Seabee Service News

REPUBLIC AVIATION CORPORATION
FARMINGDALE, LONG ISLAND, NEW YORK
SERVICE DEPARTMENT

No. 17

IMPROVED MEANS FOR SERVICING ELEVATOR TRIM TAB GEAR BOX

DOOR MATERIAL - ALUMINUM ALLOY SHEET

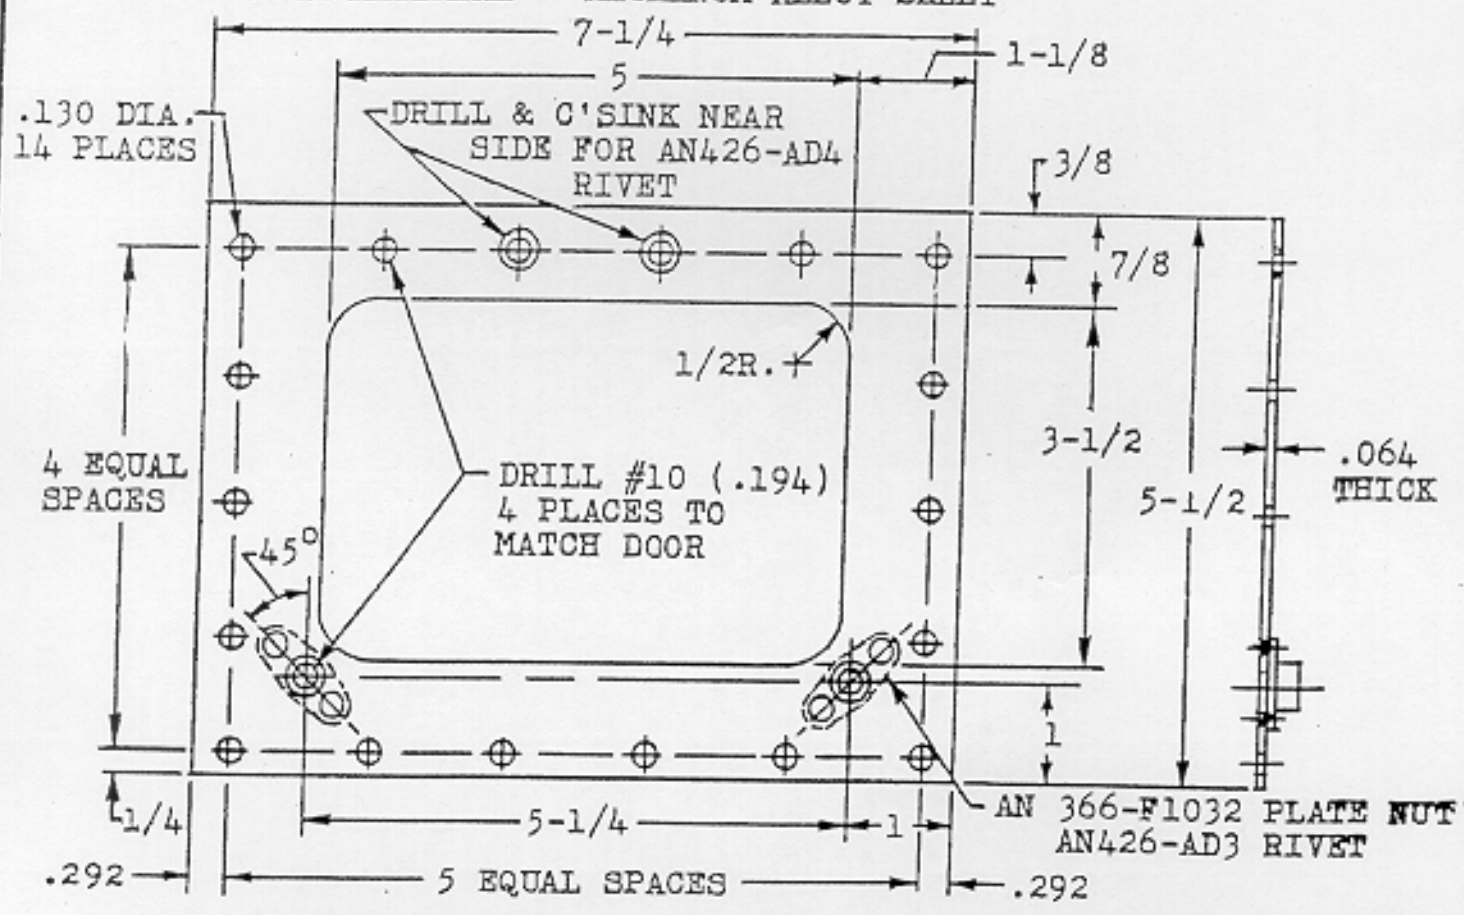
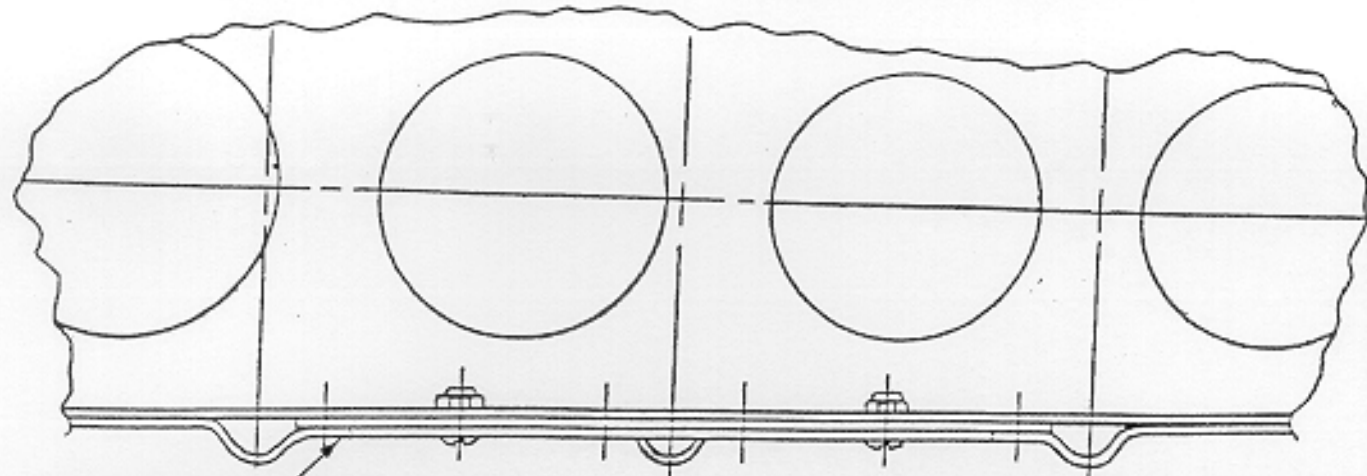
The large handholes require a door and frame for each stabilizer. These may be made in accordance with instructions on Figure 1 and installation of the frame and door may be accomplished as shown on figure 2.

RIGHT HAND HORIZONTAL STABILIZER - VIEW LOOKING UP
LEFT HAND OPPOSITE

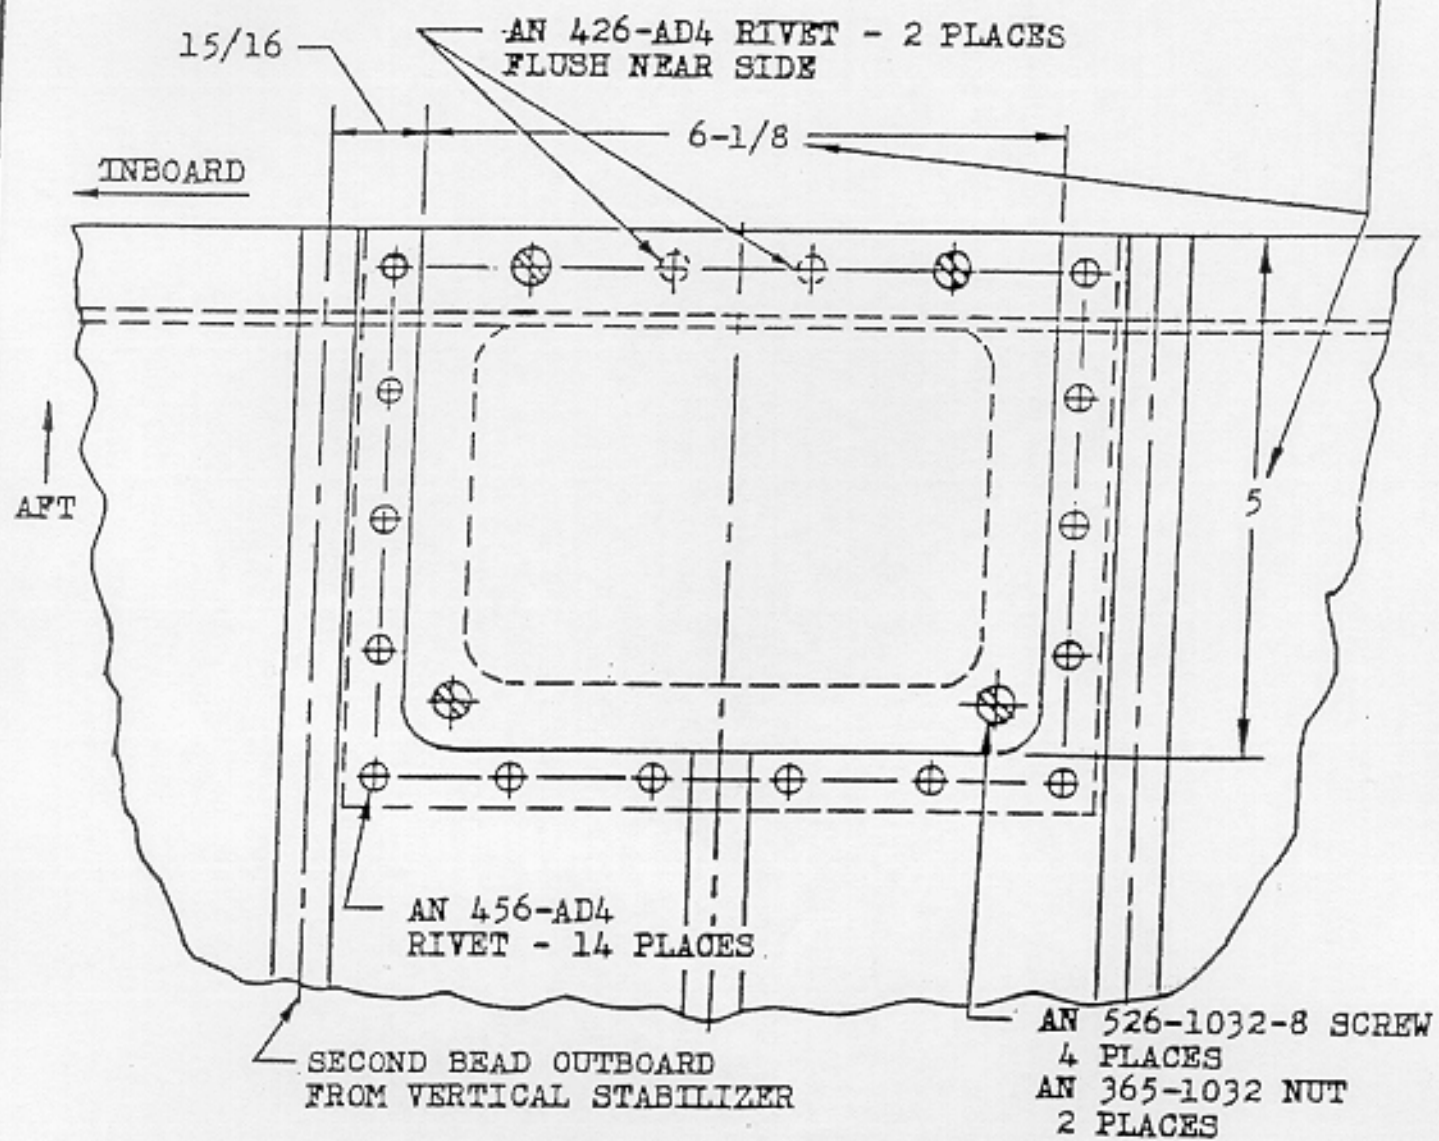
SKIN LAPS — DIMENSIONS SHOW CUT-OUT IN SKIN FOR DOOR

RIGHT HAND HORIZONTAL STABILIZER - VIEW LOOKING UP
LEFT HAND OPPOSITE

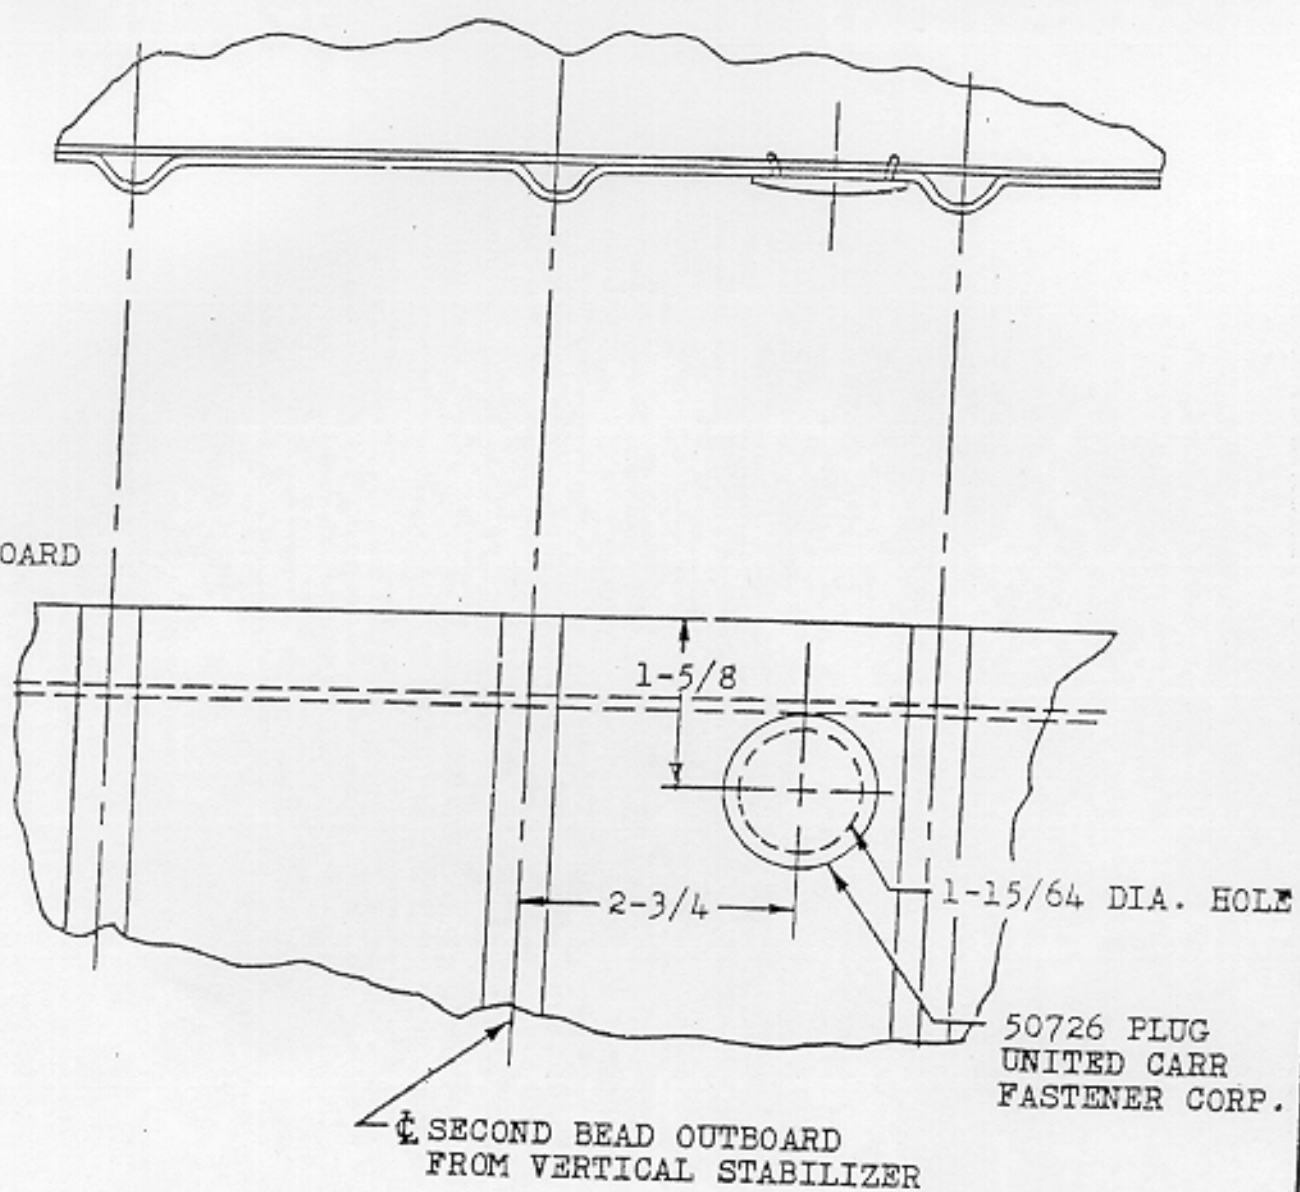
Instructions for installation of the plug buttons is shown on figure 3. These plug buttons may be ordered as spares item 1379, list price three cents apiece.
